**RE: Sea Link (EN020026) Nationally Significant Infrastructure Project (NSIP) Application – Written post hearing submissions including written summaries of oral cases made at hearings the w/c 26 January 2026 (Deadline 4) – Kent Wildlife Trust [REDACTED]**

### **Issue Specific Hearing 2 – Environmental Matters**

**Figure 2.** Recordings of most common cetacean species within the dataset. Data collected from the following sources: Marine Data Exchange, National Biodiversity Network Atlas, Sea Watch Foundation, Joint Cetacean Data Programme, Kent & Essex IFCA, National History Museum strandings.

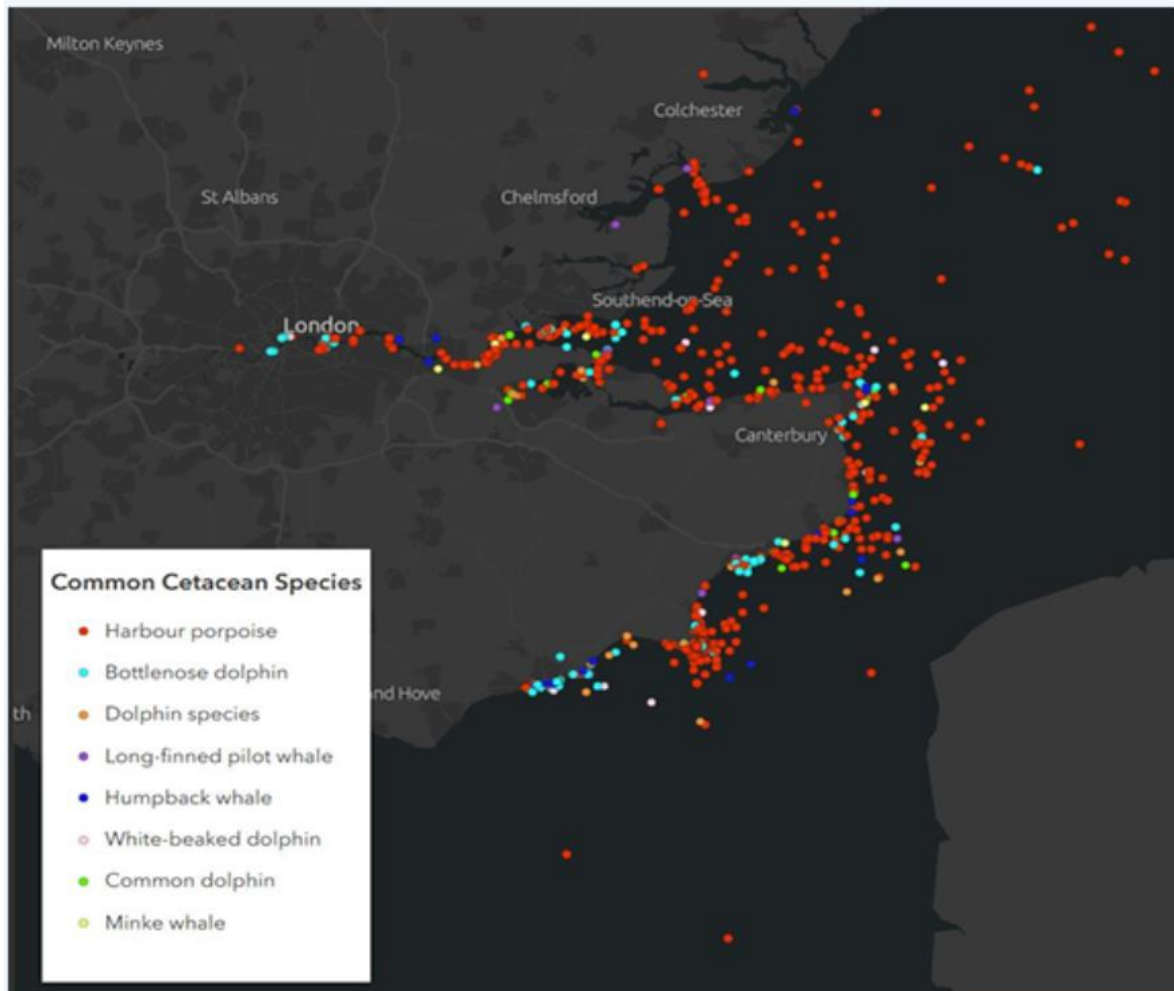
The below figures are sourced from the KDP report, with Sea Watch Foundation having kindly provided permission for their use in this Examination. They illustrate the growing body of evidence that cetaceans regularly occur in waters around Thanet and the wider Kent coastline. Figure 2 – Common Cetacean Species, shows the collated species records from MDE, NBN Atlas, Sea Watch Foundation, JCDP, KEIFCA and the Natural History Museum, and Figure 6 shows the composite heatmap of cetacean sightings, which together highlight consistent use of the wider area rather than sporadic or exceptional occurrences.

The KDP analysis demonstrates that Kent’s waters support a diverse and regularly used cetacean assemblage, including harbour porpoise, bottlenose dolphin, common dolphin, long-finned pilot whale and white-beaked dolphin, with additional occasional records of rarer species. Spatial mapping identified clear “hotspots” along the North and East Kent coast, including the Thanet coastline and areas adjacent to the wider Thames Estuary, indicating that cetaceans are not merely transient but make repeated use of this region. The findings within the KDP report directly contradict the Applicant’s marine mammal assessment and the maps included in REP1-011: Marine Mammals – Figures, which appear to suggest that species such as bottlenose dolphin, minke whale and harbour porpoise are absent from, or only rarely present within or near the Order Limits. The KDP datasets, by contrast, demonstrate regular and widespread cetacean occurrence in the wider Thanet and Kent coastal waters. It is therefore concerning that the Applicant’s assessment is so evidently out of step with this locally relevant evidence base, raising questions about the reliability of its baseline and the conclusions drawn from it.
